## Response to the Reform of the Disability Standards for Accessible Public Transport: Consultation Regulation Impact Statement

# Responses to Consultation Questions

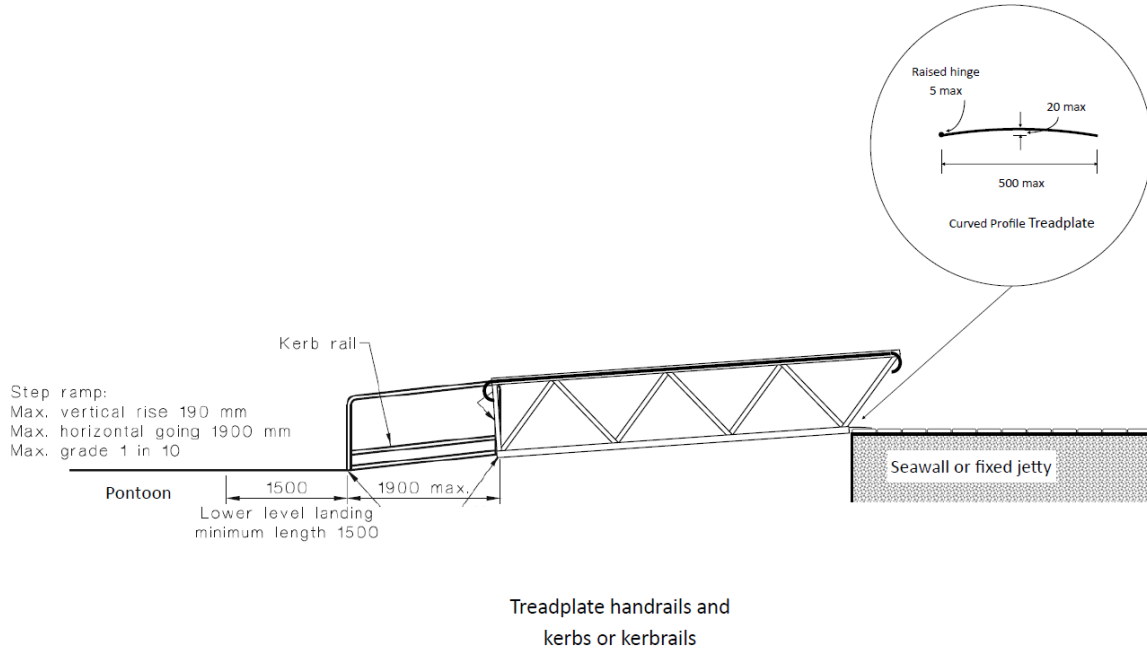
Treadplates must be provided to transition from the gangway to the fixed wharf or jetty and pontoon. The maximum slope of a treadplate connected to a gangway shall not exceed 1:10 for a maximum length of 1900mm.

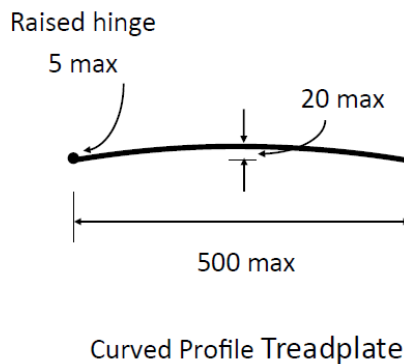
Where treadplates exceed 500mm in length then handrails and kerbs or kerb rails shall be provided.

Where a treadplate provides a curved profile then the profile shall not exceed 20mm in height and 500mm in length as shown below.

### Floating platforms/pontoons and edge safety barriers

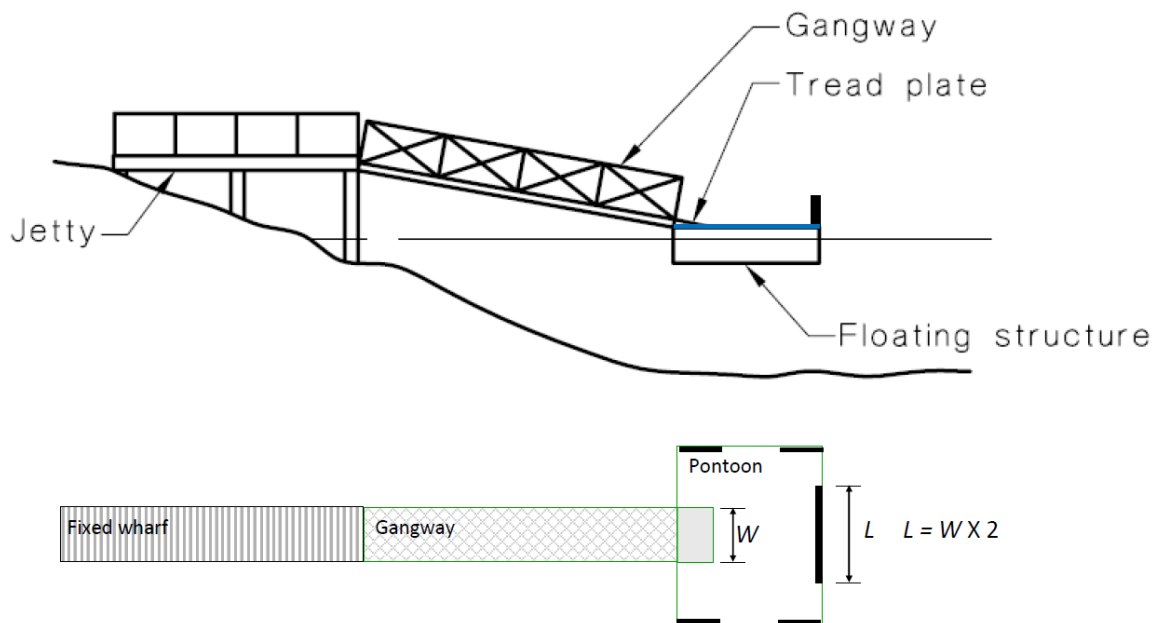
Floating platforms with connected gangways shall provide an area large enough to accommodate:

- portable boarding ramps and gangways, hoists and other boarding devices,
- queuing of expected number of users,
- wheelchair turning space at the end of a gangway and treadplate as specified by AS1428.1, and
- wheelchair turning and passing spaces as specified by AS1428.1.
